AS9924

RATIONALE

(R) BOLT, MACHINE - DOUBLE HEXAGON EXTENDED WASHER HEAD, DRILLED, PD SHANK, CADMIUM PLATED, STEEL, UNS G87400, 125 KSI MIN, .2500-28 UNJF-3A

FIGURE 1 - BOLT

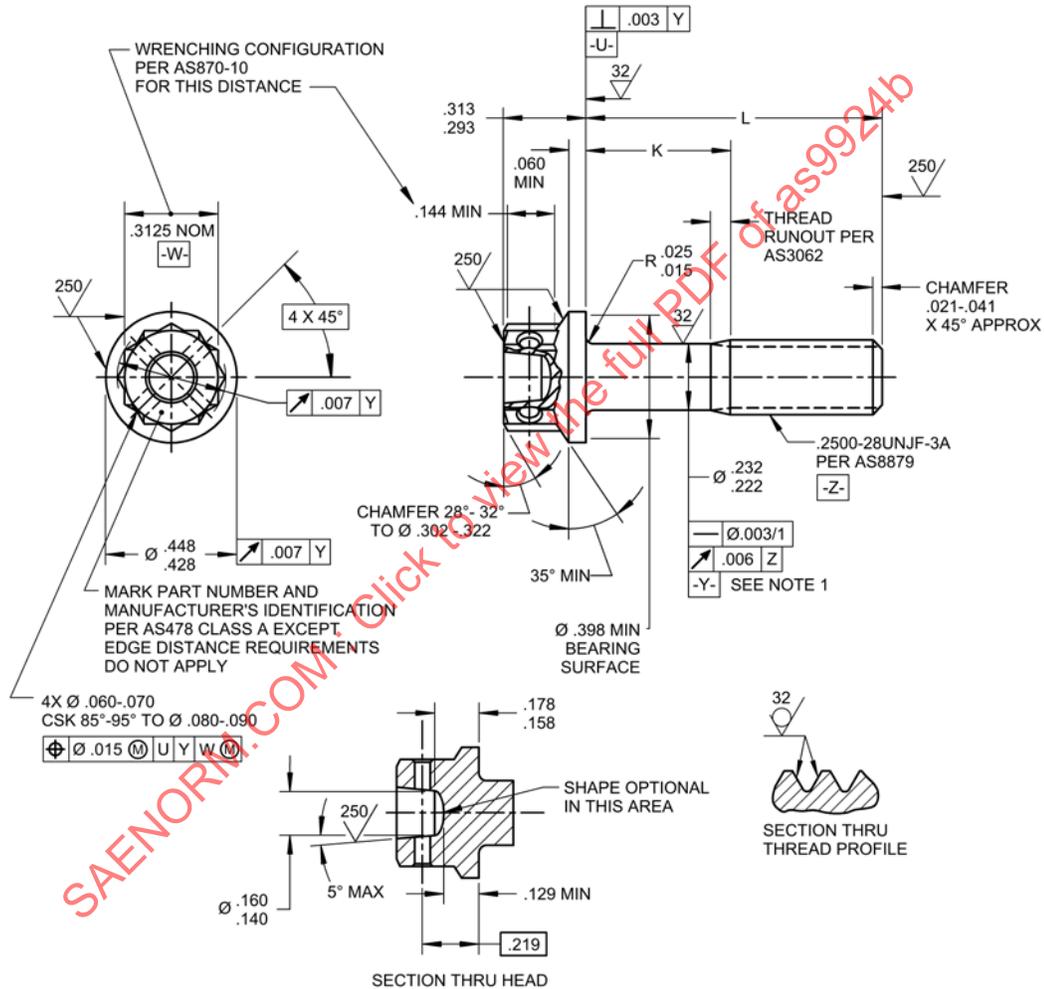
RESTORE ORIGINAL MAGNETIC PARTICLE TEST REQUIREMENT, REVISE LIGHTENING HOLE CONFIGURATION TO ALLOW OPTIONAL SHAPE, ADD EDGE DISTANCE EXCEPTION FOR HEAD MARKING, UPDATE THREADS TO AS8879, UPDATE COLD ROLLING DRAWING NOTE, UPDATE SURFACE FINISH REQUIREMENTS, DELETE .015 MAX RADIUS AT BASE OF WRENCH PAD, AND FIGURE 1 REDRAWN
